CERTIFICATE OF APPROPRIATENESS**Application Date:** August 3, 2014**Applicant:** Michael & Laura Czapski, owners**Property:** 528 Highland Street, Lot 8 & Tract 7, Block 20, Woodland Heights Subdivision. The property includes a historic one-story residence situated on a 7,500 square foot (75' x 100') corner lot.**Significance:** Contributing Queen Anne residence with Colonial influence, constructed circa 1915, located in the Woodland Heights Historic District.**Proposal:** Alteration – Request for HAHC approval of completed and partially completed alterations that have exceeded the scope of work approved in two previous COAs.

The applicant received a COA in February 2014 for a two-story rear addition to a one-story contributing house. In March, the applicant was red-tagged for removing all of the shiplap from the original house without approval. He was granted a COA in April 2014 for this unapproved work.

WEST SIDE ELEVATION (FACING NORTHWOOD STREET)

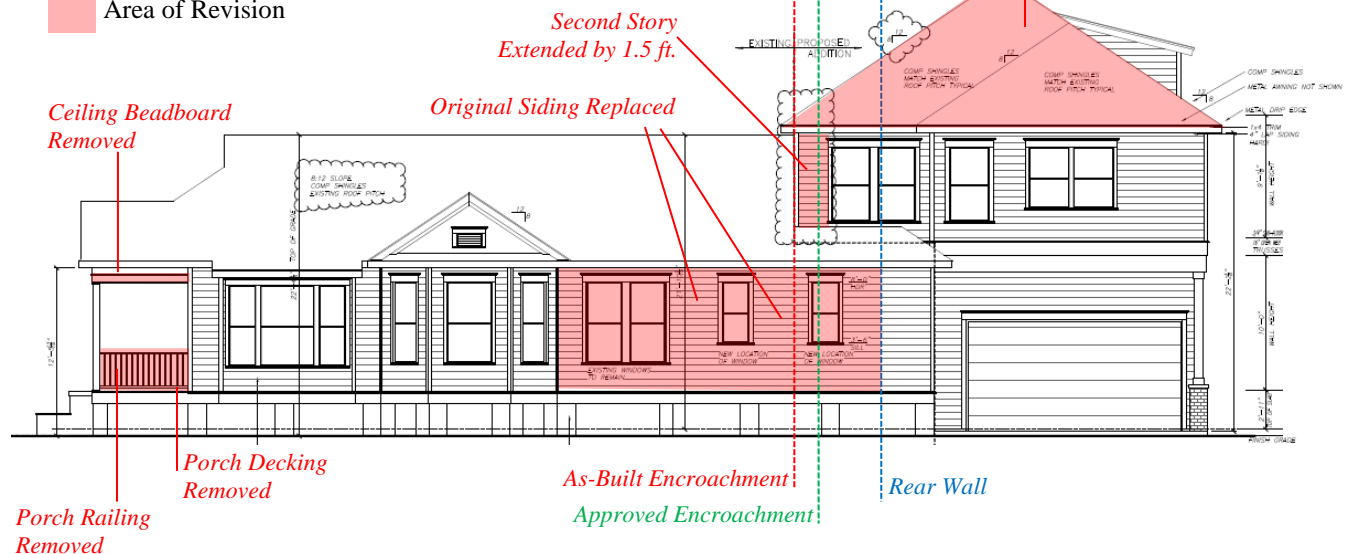
Roof Pitch Altered and Ridge Height Increased by 2'

EAST SIDE ELEVATION

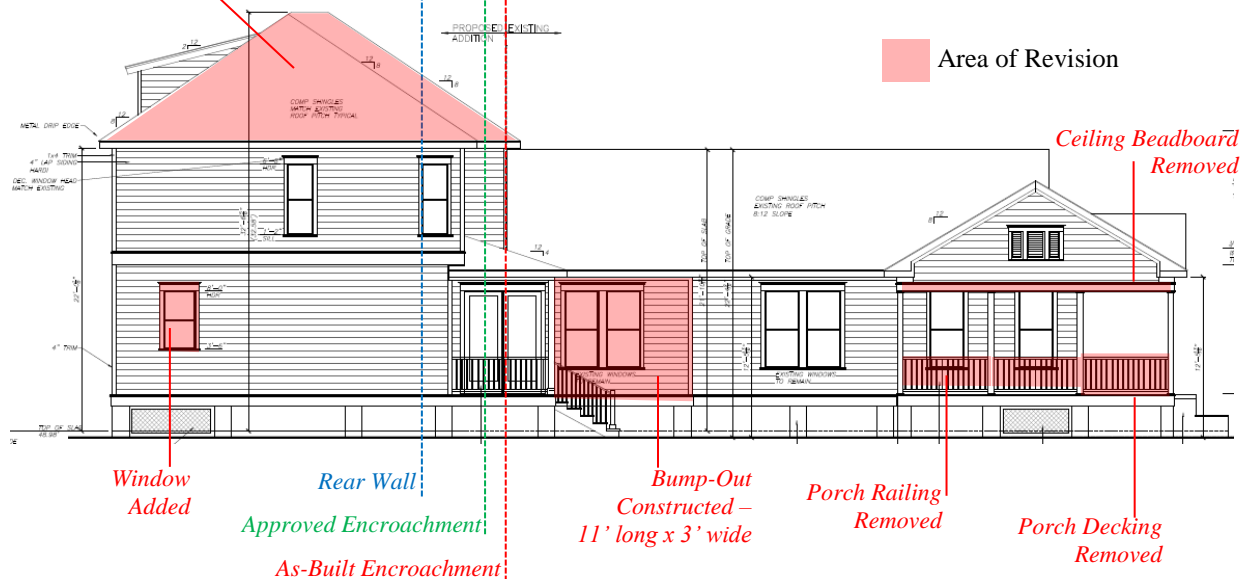
*Roof Pitch Altered and
Ridge Height increased by 2'*

*Ceiling Beadboard
Removed*

*Porch Railing
Removed*

*Porch Decking
Removed*

*Bump-Out
Constructed –
11' long x 3' wide*

As-Built Encroachment

Approved Encroachment

SOUTH (REAR) ELEVATION

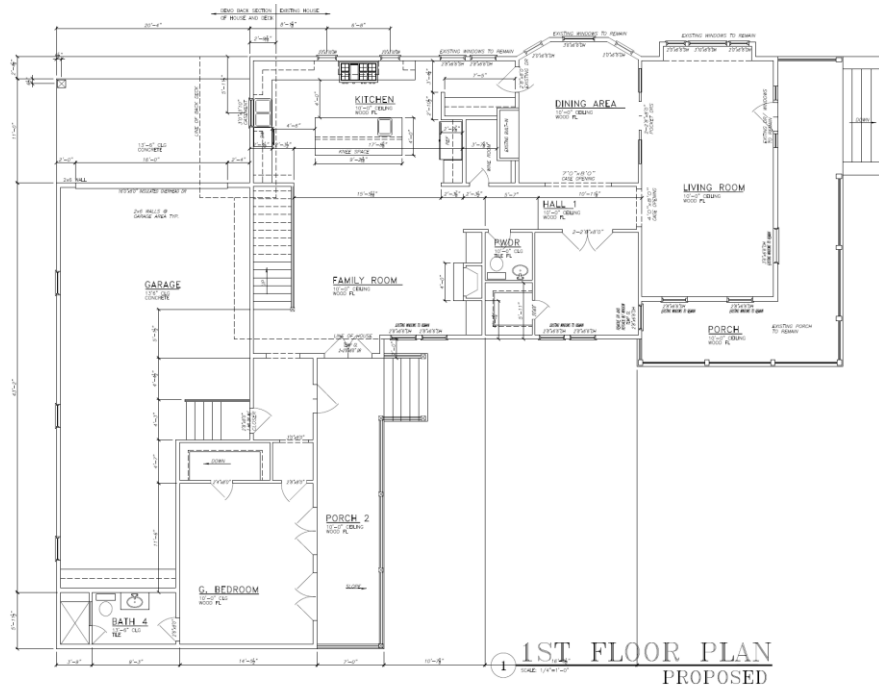
*Roof Pitch Altered
and Ridge Height
increased by 2'*

FIRST FLOOR PLAN

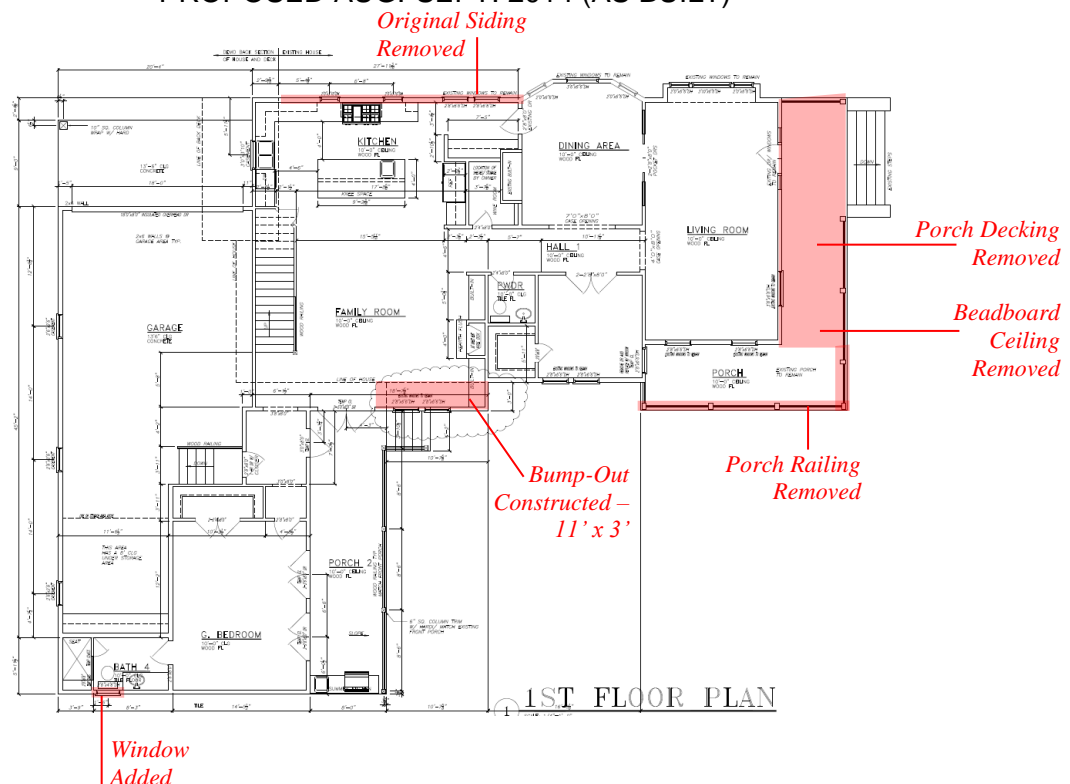
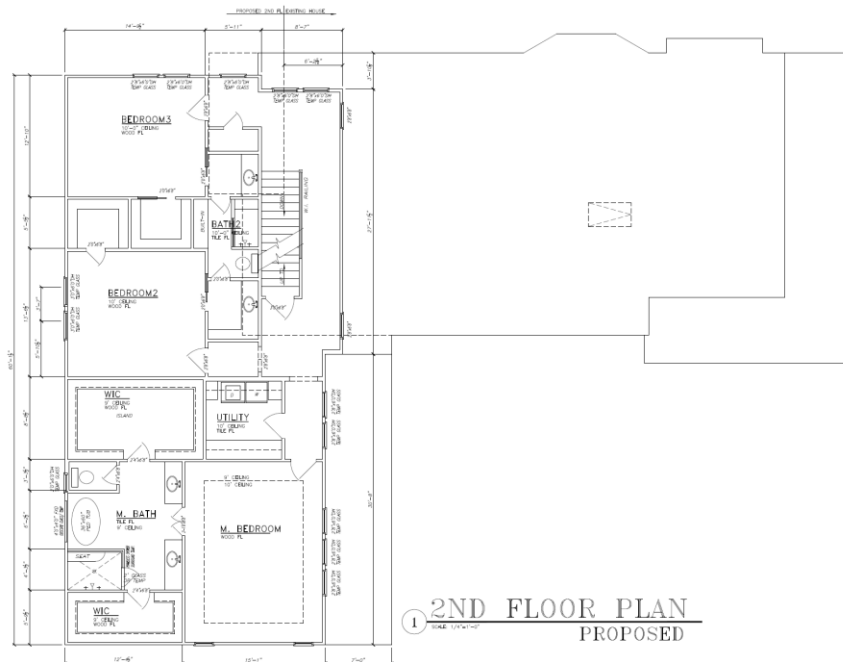
Area of Revision

SECOND FLOOR PLAN

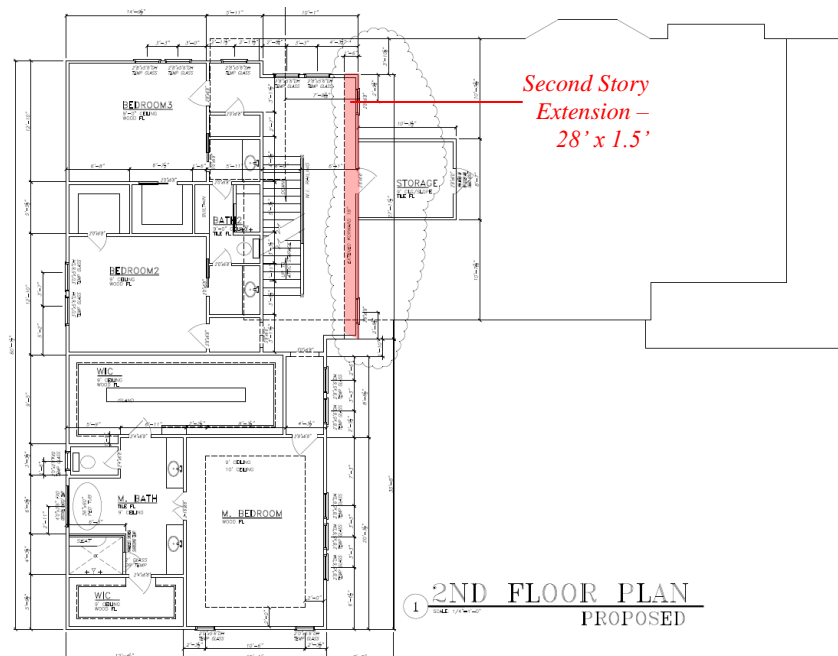
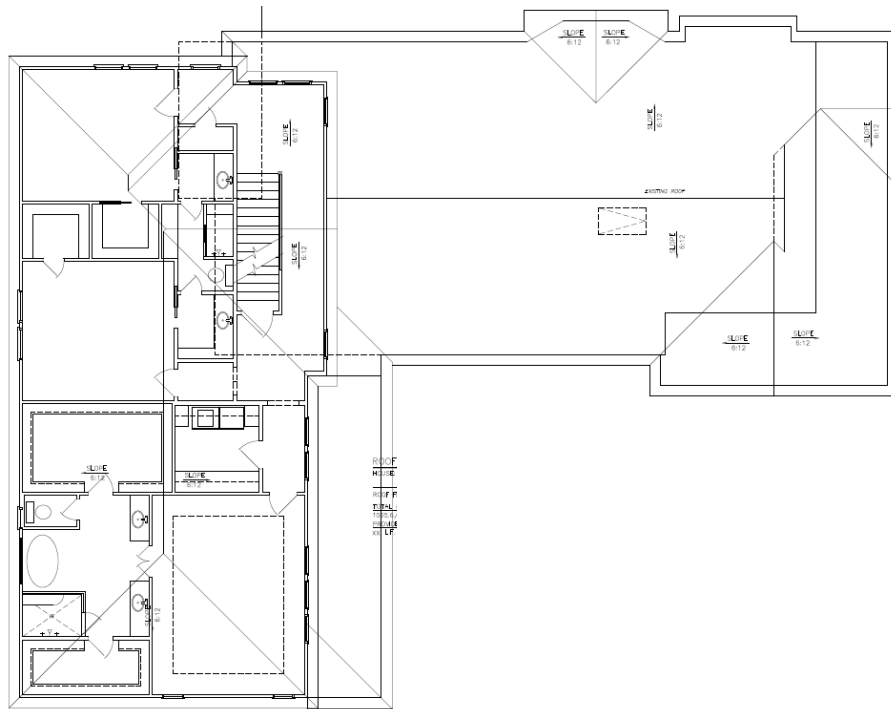
Area of Revision
